Subject: Hope Bay - Tail Lake Discharge Pipe

Job No: 1CH008.033

North Dam Tail Lake Discharge Pipe

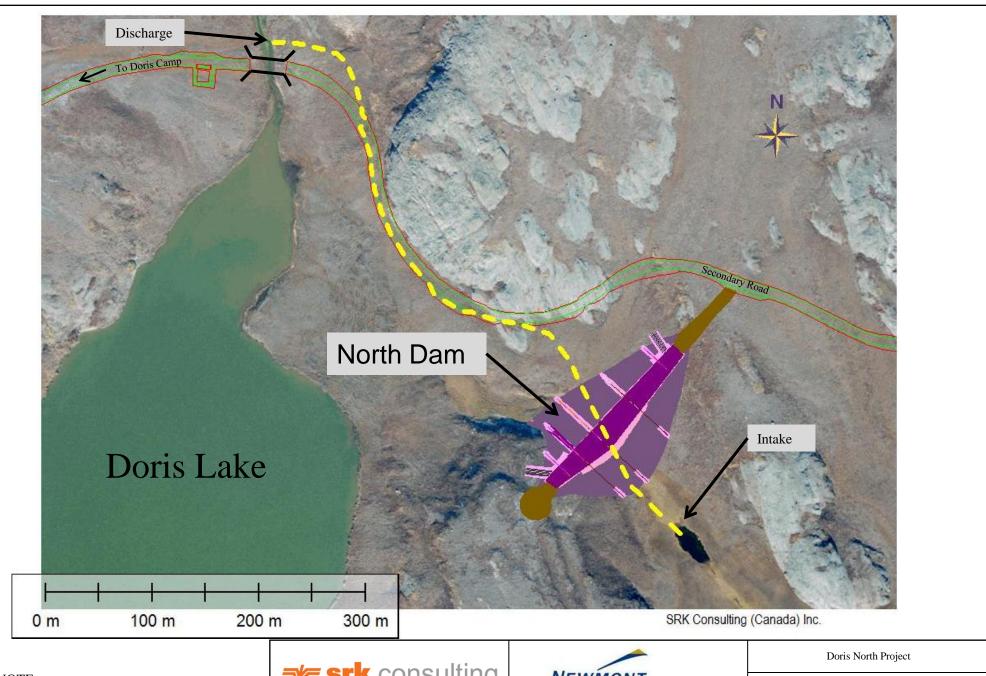
Based on our observations and discussions with the Contractor, the pipeline constructed to discharge water from Tail Lake into Doris Creek is routed over the North Dam and along the Secondary Road. The yellow line on the attached figure shows the approximate alignment of the pipeline as understood by SRK.

SRK wishes to express its concerns regarding the possibility of a leak from the Victaulic pipe joints located within the dam footprint. An uncontrolled supply of water to the frozen core could induce localised thawing and degradation of the core material. Any degradation will have to be remediated before the raise of the core to its final elevation can resume this coming winter.

To ensure that any leaks are detected in a timely manner, continuous monitoring of the pipeline should be implemented during pumping. If a leak occurs, pumping shall be stopped immediately and the source of the leak eliminated before pumping can resume.

No excavation into the ROQ cover protecting the frozen core shall be made without the approval of the SRK Site Engineer.
